Noise Symptom - Creaking Noise From Rear End Area: Checking coil springs on rear axle (SY 37/19)

Vehicle Type: 911 GT3 Gen. II (991)

Subject: Coil springs on rear axle

Coil spring on rear axle

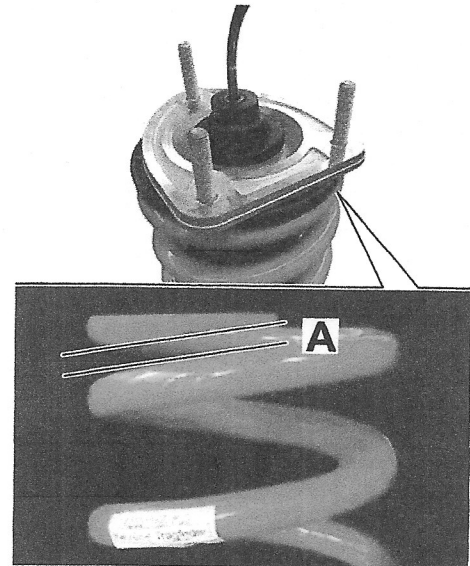
Cause: The end of the spring may be touching the closest coil and this can make the noise.

2.1 Visually check whether the coils were touching — you may see signs of paint abrasion on the coils (⇒ *Coil spring on rear axle -Markings A-*).

- 2.2 If the coils were touching, replace old coil springs on the rear axle with new coil springs with shrink-fit hose, see ⇒ *Workshop Manual '427137 Disassembling and assembling rear spring strut'*.
